## DESCRIPTIVE REPORT

*Registry No.* H-11050

*General Locality* Zimovia Strait

*Sublocality* Anita Bay

Figure 4. HDCS DTM of wreck

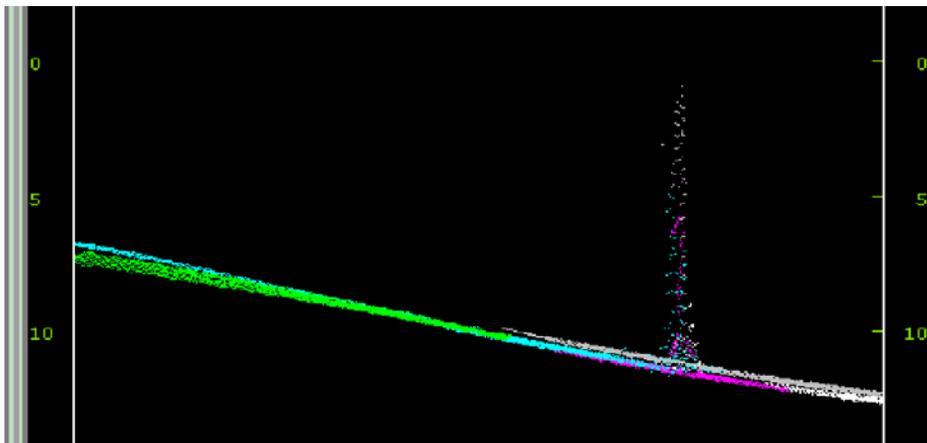
A new wreck was located at 56°11'20.40"N, 132°25'57.78"W (659,313.2E, 6,230,081.5N) with a least depth of 10.3 meters (see figures 4 & 5). The least depth was obtained with SWMB and verified by divers. The dive investigation report is included in Section I<sup>27</sup> of *Separates to be Included with Survey Data*. The dimensions of the wreck measured 4.9 meters (16.2 feet) wide, 1.8 meters (6.0 feet) tall, and 17.7 meters (49.0 feet) long. The wreck appeared to be a wooden barge. The Hydrographer recommends charting a wreck of known depth in this position.<sup>28</sup>

- <sup>27</sup> Filed with the hydrographic data
- <sup>28</sup> Concur. Chart 5.5 wreck as depicted on the smooth sheet.
- <sup>29</sup> ~~Strikethrough 56°11'28.17"N, 132°30'15.56"W (654,862.2E, 6,230,158.5N)~~ and replace with 56°11'28.20"N, 132°30'15.39"W (654,865.0E, 6,230,159.5N).

**FIX NUMBERS: 20124- 20127**

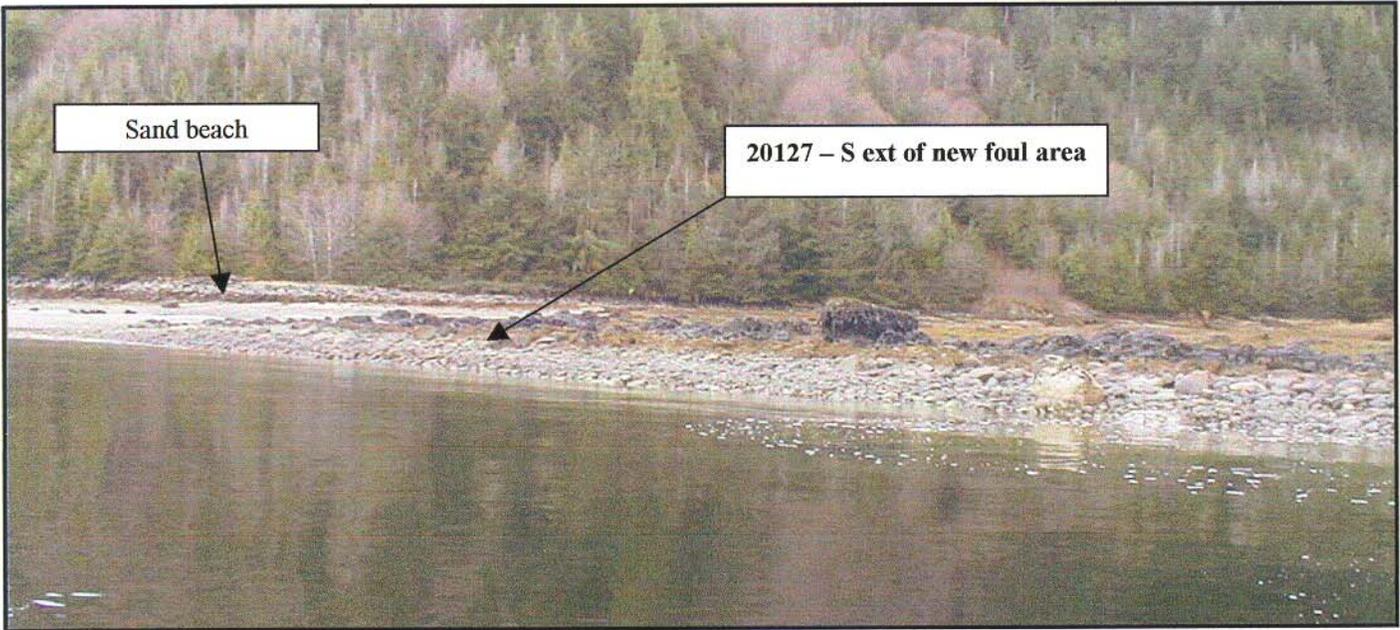
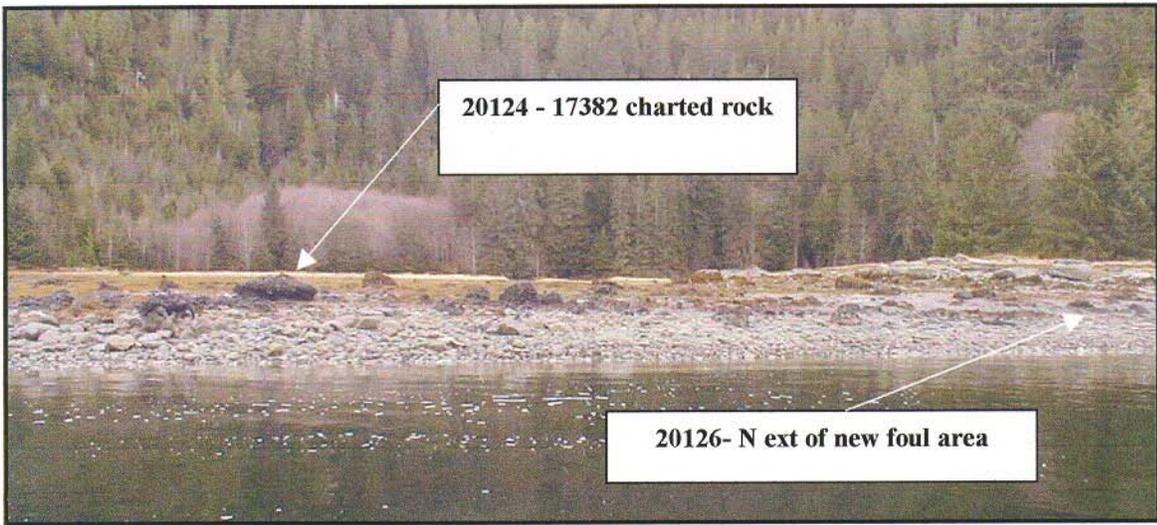
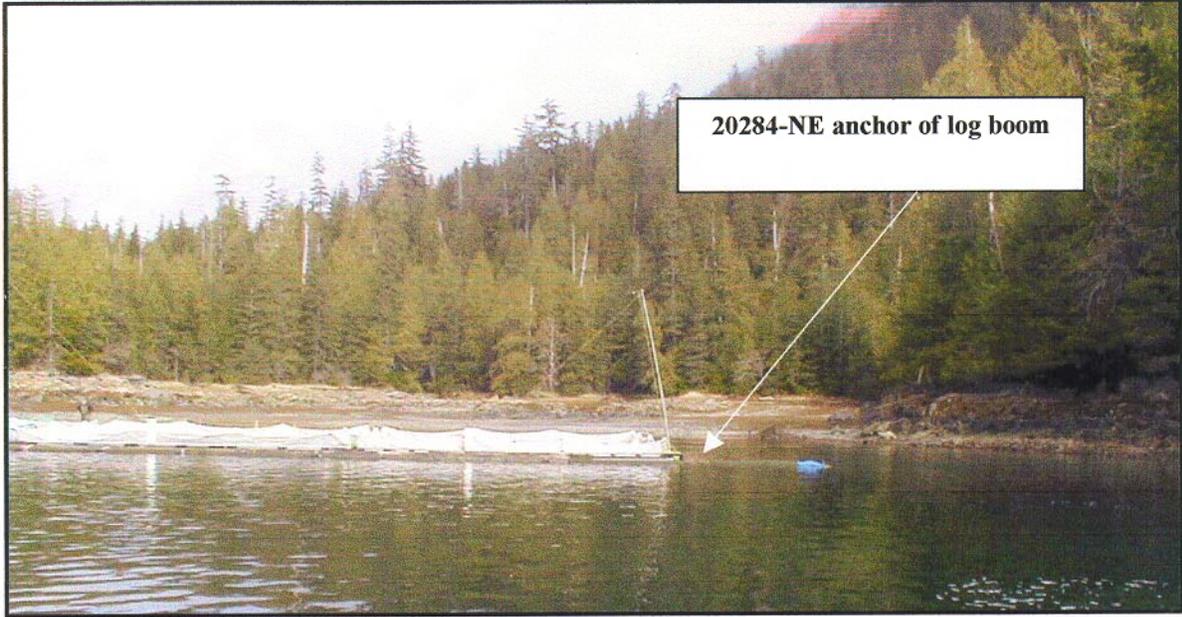
A new foul area, located at the northwest corner of Anita Bay, centered on position 56°13'46.83"N, 132°24'20.03"W (660,827.3E, 6,234,670N), was delineated by detached positions 20126 and 20127. The area is foul with boulders. Refer to Appendix VII<sup>38</sup> for digital photographs of the new foul area.

The position of the two charted (17382) rocks located at 56°13'49.29"N, 132°24'26.37"W and 56°13'46.79"N, 132°24'26.40"W were positioned 80 meters east-southeast at 56°13'48.68"N, 132°24'21.60"W (660,798.3E, 6,234,726.0N, Pos. # 20,124) and 56°13'47.08"N, 132°24'21.07"W (60,809.1E, 6,234,677.0N, Pos. # 20,125), respectively, during shoreline verification. The Hydrographer recommends revising the positions of the charted rocks.<sup>44</sup>

- <sup>37</sup> Concur. DP and BS plot is filed with the hydrographic data.
- <sup>38</sup> Copy attached to this report. The evaluator recommends charting this foul area as depicted on the smooth sheet.

- <sup>44</sup> Concur
- <sup>45</sup> Concur with clarification. Shoreline verification provided by the hydrographer was analyzed during office processing and shown on the smooth sheet as warranted. The evaluator recommends that the smooth sheet be used as the charting source.

**OPR-O327-RA-01  
H-11050  
SHEET M  
FIX NUMBERS: 20284, 20285, & 20286**

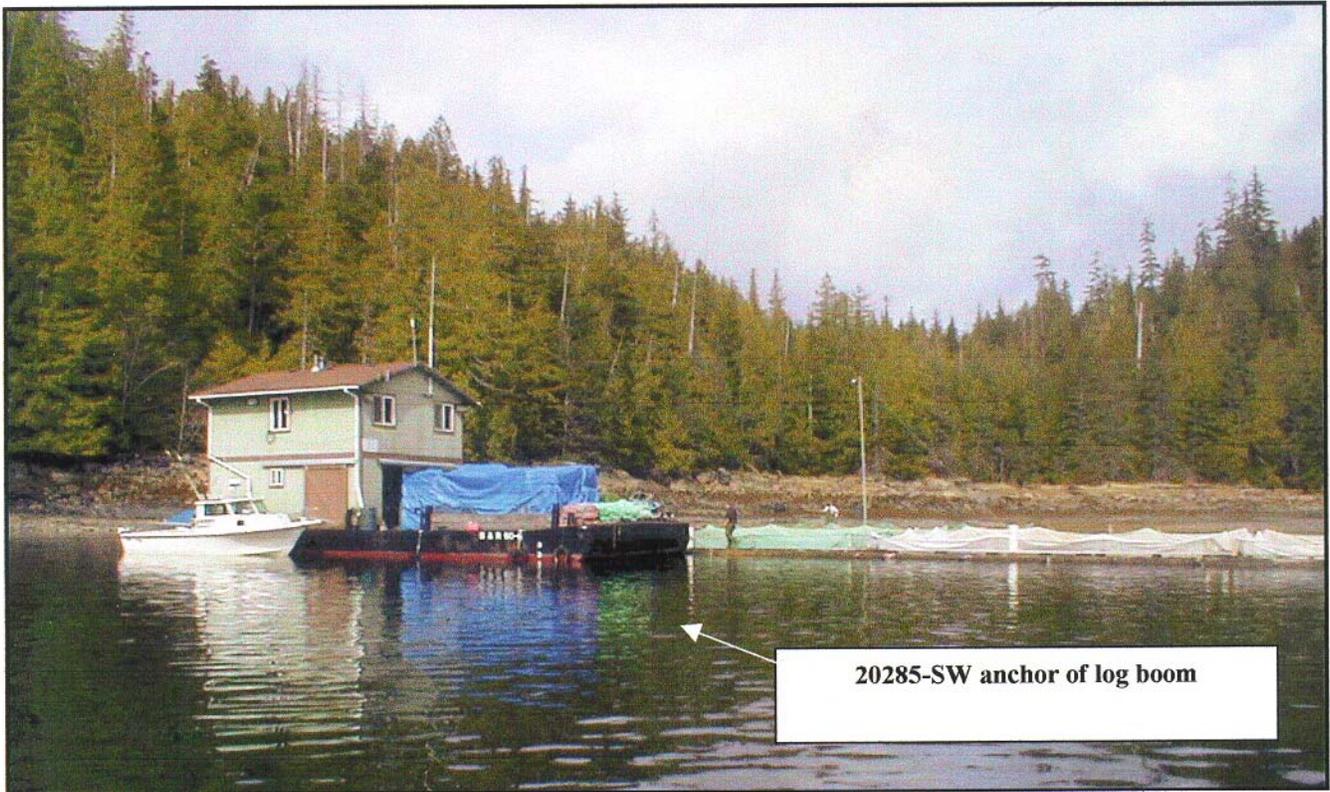
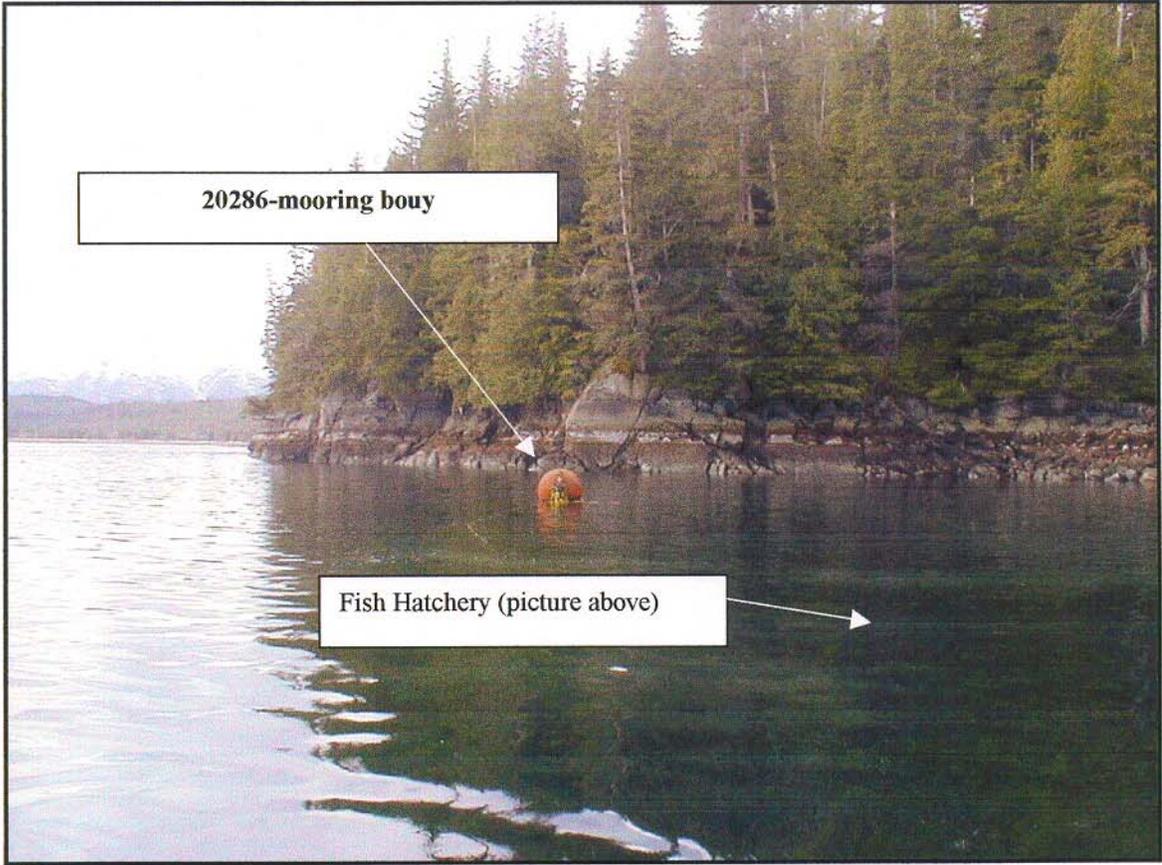
A new fish hatchery was located in a small inlet along the northwest shore of Anita Bay, centered on position 56°12'07.28"N, 132°29'06.06"W (656015.7E, 6,231,410.6N). A log boom was positioned across the inlet, delineated by positions 20284 and 20285. A mooring buoy was positioned 40 meters offshore of the log boom (Pos.#20286) at 56°12'4.62"N, 132°29'5.26"W (656,033.3E, 6,231,328.5N). The Southeast Alaska Regional Agriculture Association (SARAA) operates the fish hatchery. Refer to Appendix VII<sup>39</sup> for digital photographs of the hatchery.

- <sup>39</sup> Copy attached to this report. The evaluator recommends charting this area as depicted on the smooth sheet.
- <sup>40</sup> A digital photograph of the floating pier was not provided by the hydrographer. The evaluator recommends charting the floating pier as depicted on the smooth sheet. The two piles located at the base of the pier cannot be depicted based on chart scale.

**FIX NUMBER: 20288**

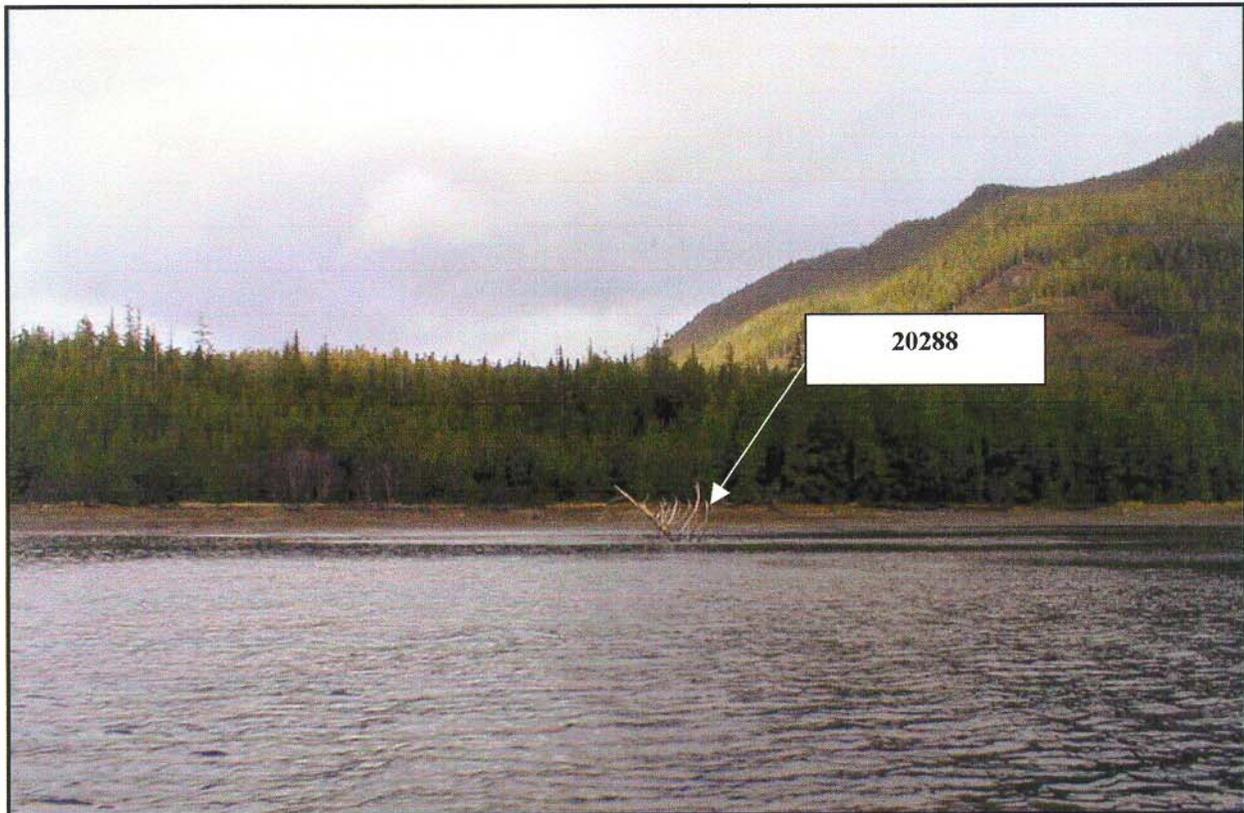
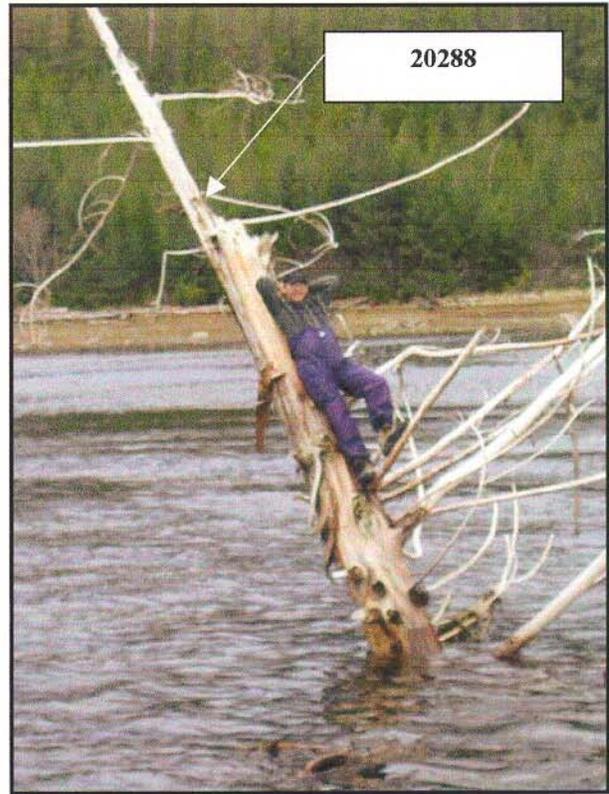
A tree was located at the head of Anita bay, at 56°11'28.17"N, 132°30'15.56"W (654,862.2E, 6,230,158.5N)<sup>29</sup> Position # 20288. The tree was firmly anchored to the bottom and oriented at a slight angle. The tree was present in the same position throughout the duration of the survey. During shoreline verification, the tree was exposed approximately four meters above low water. SWMB depths acquired over the tree were flagged as outstanding in HDCS. The following (Figure 6) is the SWMB data acquired over the tree, displayed in HDCS subset mode. This includes data from RA1 DN-101 (line 013\_1834) and DN-2 (lines 034\_1834 and 033\_2245).<sup>30</sup>

- <sup>30</sup> The evaluator recommends charting a snag as depicted on the smooth sheet.
- <sup>31</sup> Concur
- <sup>32</sup> Concur. Chart 17382, 1:80,000 covers the entire area of the present survey and was used for comparison during office processing.
